**REMARKS**

**ITEM 2: OBJECTION TO THE DRAWINGS**

**IN THE DRAWINGS:**

FIG. 3A (BACKGROUND)

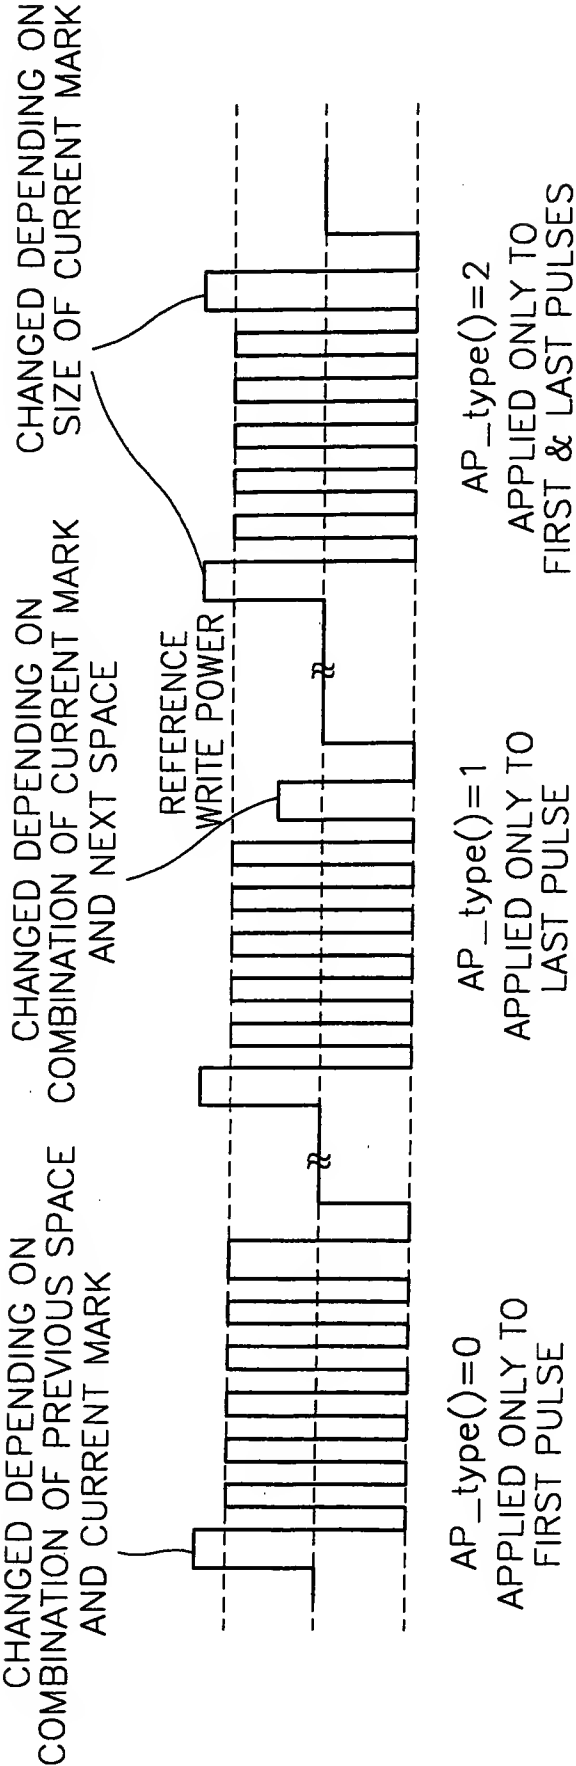
Item 2 of the Action objects to the drawings. The Examiner contends that figures 3A and 3B should be designated by a legend such as -- PRIOR ART -- since only that which is old is illustrated

The Examiner incorrectly contends, using the support for the rejection of claim 1 as an example, that a method comprising "forming a mark using a multiple pulse train comprising a first pulse, a multi-pulse having a peak power level and a last pulse" is discussed by "Fig. 3A, first pulse at beginning of pulse chain, multi-pulse in the middle of pulse chain and last pulse at the end of pulse chain" and "adapting a power level of the first pulse relative to the peak power level of the multi-pulse depending on a correlation between the mark and a previous space" is discussed by "Fig. 3A, the changed depending on combination of previous space and current mark" and "adapting a power level of the last pulse relative to the peak power level of the multi-pulse depending on a correlation between the mark and a next space" is discussed by "Fig. 3A, the changed depending on combination of current mark and next space." (Action at pages 4-5).

Applicant points out that FIG. 3A discusses:

a first multiple pulse train, the power level of a first pulse is adjusted according to a combination of a previous space and a current mark. In a second multiple pulse train, the power level of a last pulse is adjusted depending on a correlation between a current mark and a next space. In a third multiple pulse train, the power levels of first and last pulses are adjusted depending on the size of a current mark regardless of a correlation between a mark and a space.

As seen from a comparison of FIG. 3 A and FIG. 6, FIG. 3A does not discuss the method recited by claim 1 "forming a mark using a multiple pulse train comprising a first pulse, a multi-pulse having a peak power level, and a last pulse; adapting a power level of the first pulse relative to the peak power level of the multi-pulse depending on a correlation between the mark and a previous space; adapting a power level of the last pulse relative to the peak power level of the multi-pulse depending on a correlation between the mark and a next space."

In light of this objection, replacement figures are submitted herewith as suggested by the Examiner. FIGS. 3A and 3B are labeled "BACKGROUND" and replace previous FIGS. 3A and 3B. Approval of these changes to the drawings and withdrawal of the objection is requested.

Item 2 of the outstanding Office Action objects to the drawings. In light of these objections, replacement figures are submitted herewith. FIGS. 3A and 3B are labeled "BACKGROUND" and replace previous FIGS. 3A and 3B. Approval of these changes to the drawings is respectfully requested.
